File: Variance Request
 8457 Sunset Road NE

From: Lauren Walburg,
 Stantec

Date: September 27, 2021

Re: Bob Fearing – Variance, Side Yard Setbacks and Front Parking Setback, 8457 Sunset Road NE

Zoning Map

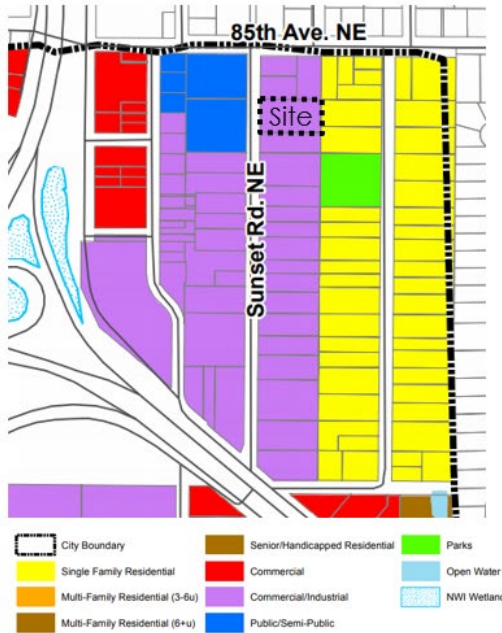
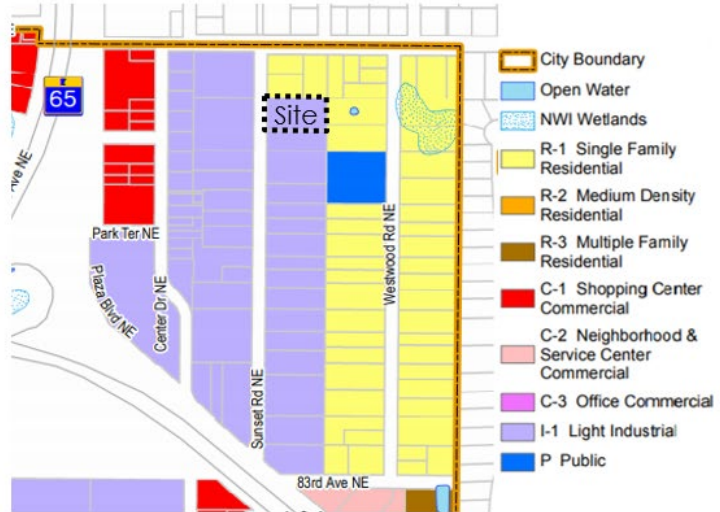
The land use and zoning pattern in the area is complex, but the request is simple (see map excerpts above):

- The site at 8457 Sunset Road NE is guided Commercial/Industrial and zoned I-1 Light Industrial.
- The Eagle Brook Church across Sunset Road NE is guided Public/Semi-Public but zoned I-1 Light Industrial.

- The homes to the north are guided Commercial/Industrial but zoned R-1 Single Family Residential.
- The homes to the east are guided and zoned Single Family Residential.

- In the Metropolitan Area, cities are obliged to have the zoning conform to the Land Use Plan. The Land Use Plan take precedence over the zoning.
- The single family homes north of the site could therefore be rezoned and redeveloped with Industrial uses at any time – the City would be obliged to rezone the property to I-1 to conform with the Land Use Plan.

- The request is for a variance to the side setback to the north that is the same as a future industrial use would require (if zoned according to the Land Use Plan) vs. what the existing residential uses require.

SITE PLAN

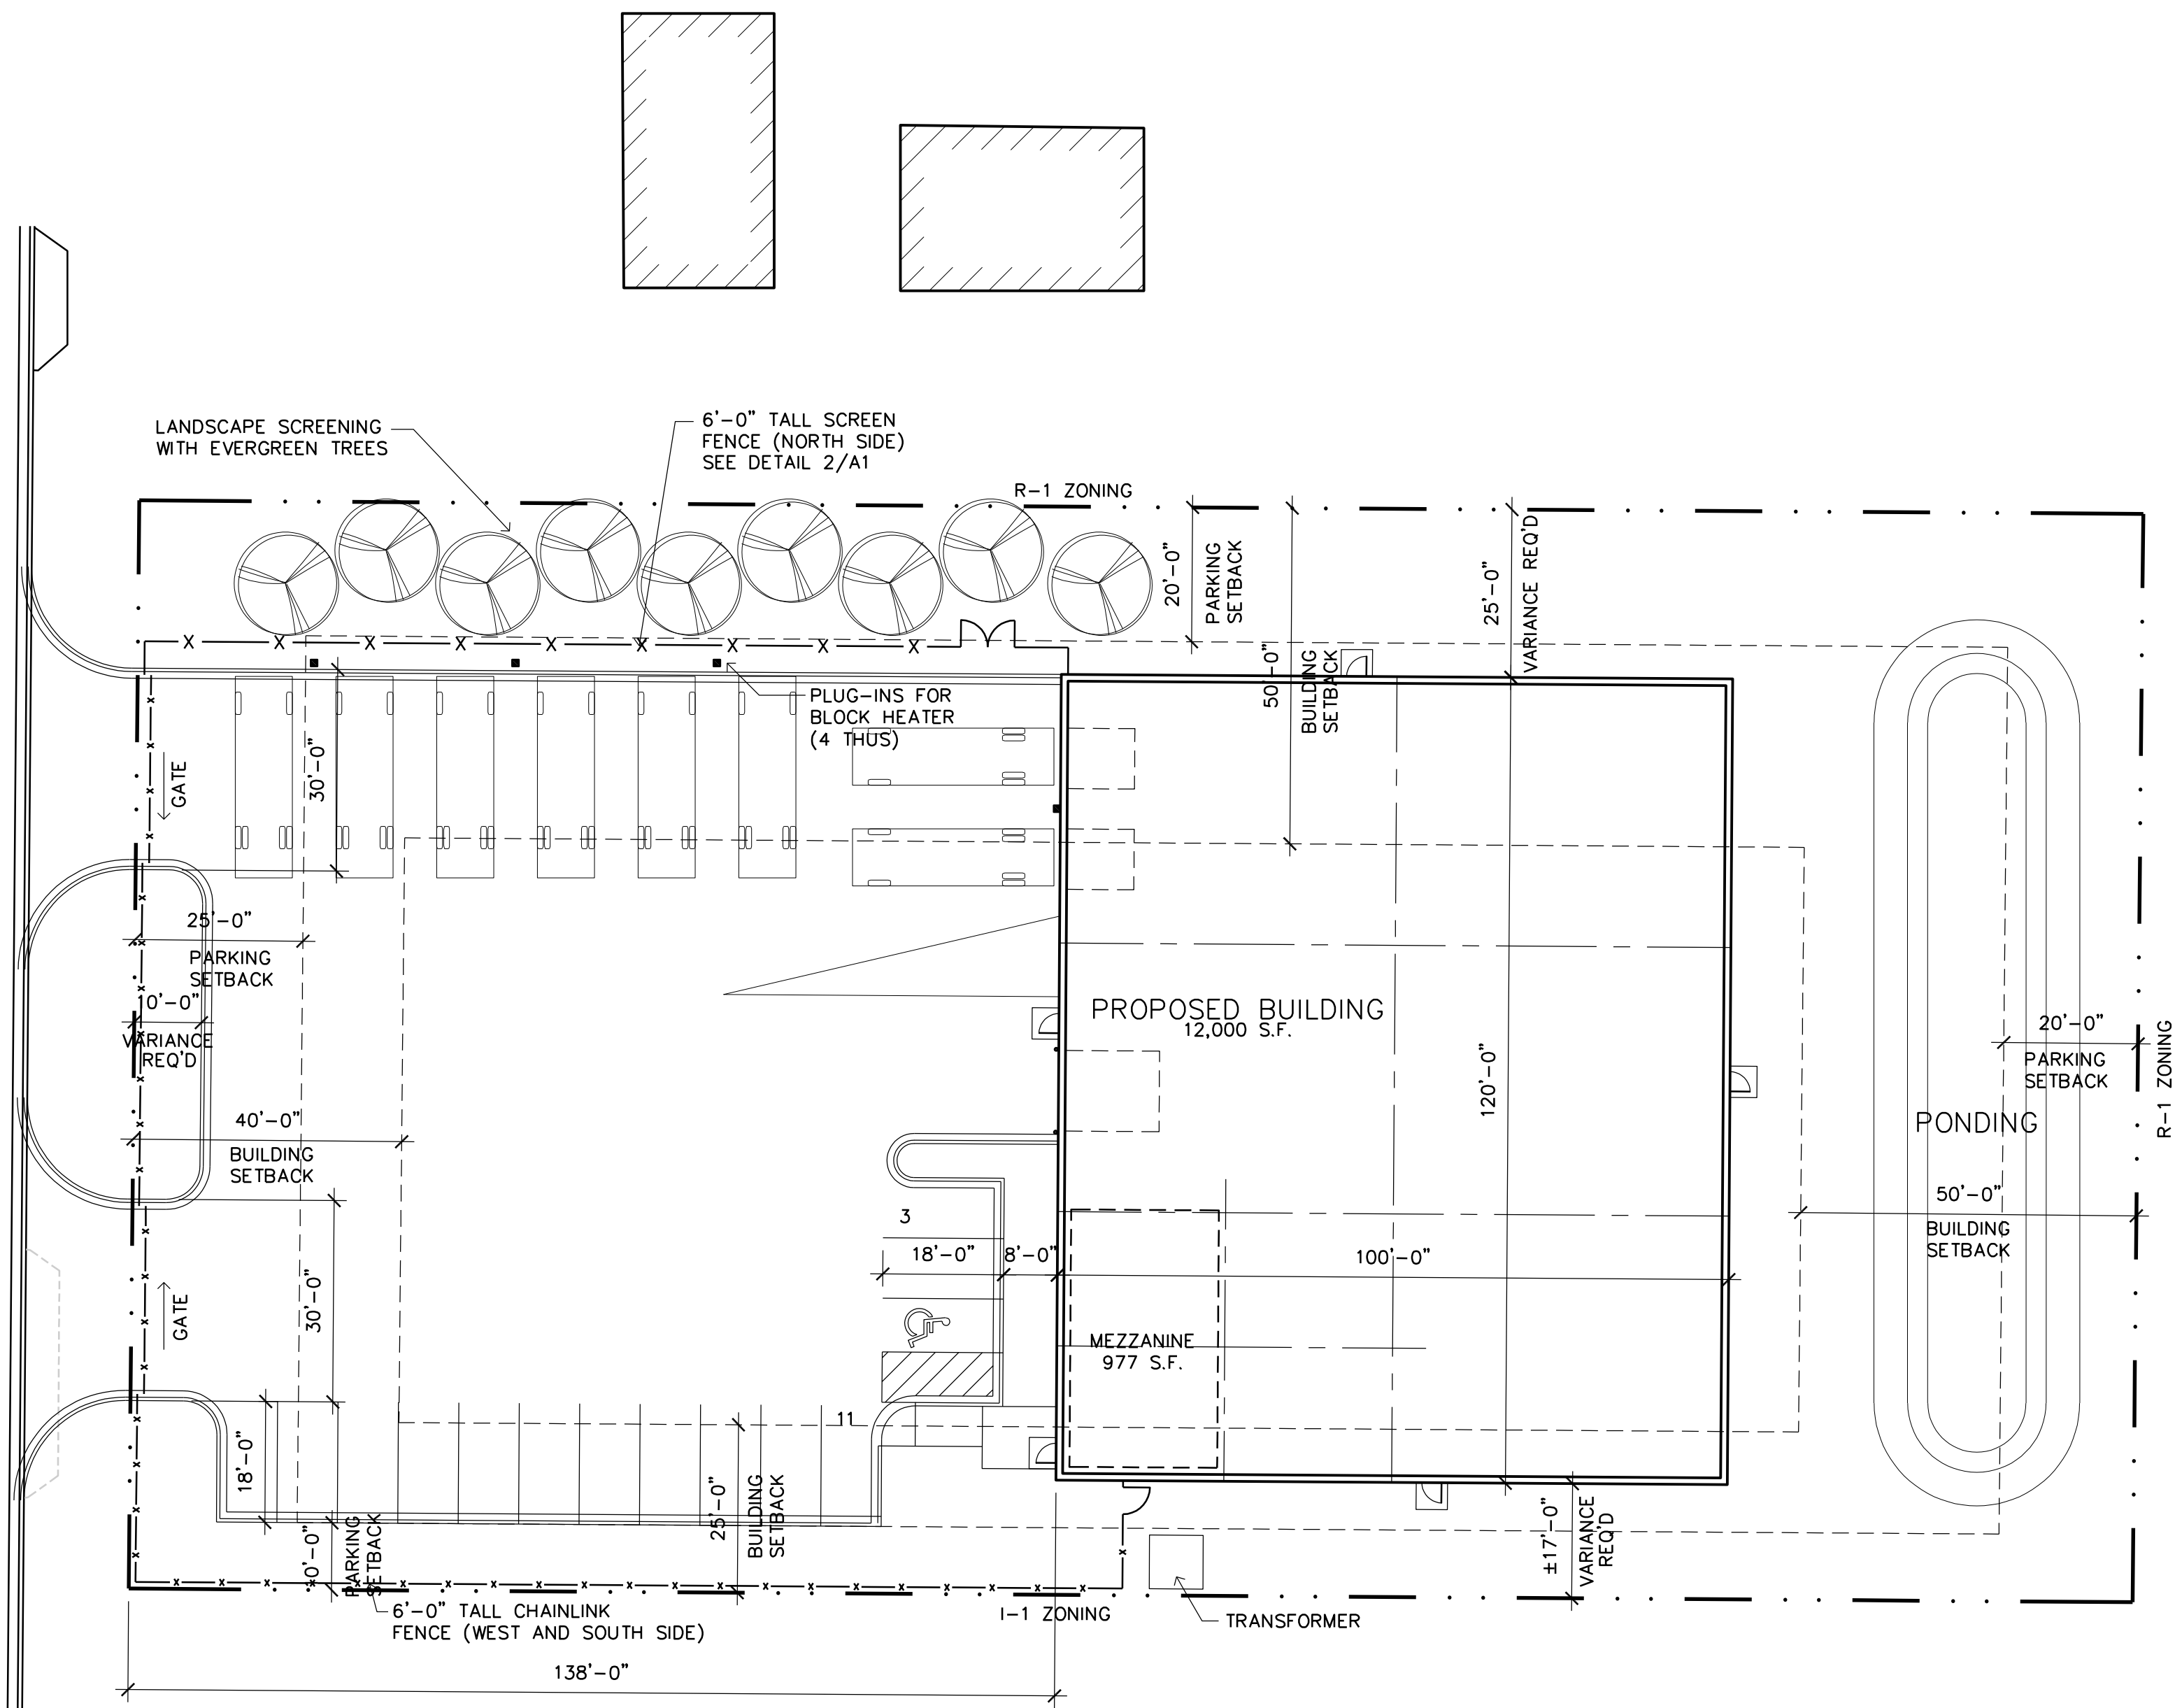
The site plan is laid out to have a sturdy 8 foot fence and landscaping facing north to the existing residences. Screening is required for all parking areas abutting residential uses per Zoning Code Section 153.138, but that will be handled in the Site Plan review process and no variance is requested for that here.

- 1) The side setback to the north is approved at 25 feet vs. the required 50 feet only if the main entrance to the building is not located on the north side and requested fence and landscaping is installed as indicated on the site plan.
- 2) Variances to the side setback to the south and parking setback in the front yard are approved only if the entire site is fenced for security.
- 3) Landscaping shall be provided in the north side yard as suggested on the site plan, with details to be reviewed and approved by the City Planner at the time of Site Plan review.
- 4) All other details of the proposed development will be reviewed in the Site Plan review process, including grading, drainage, stormwater management, landscaping and screening, signage, lighting, number of parking spaces, and other details as required by City Code.
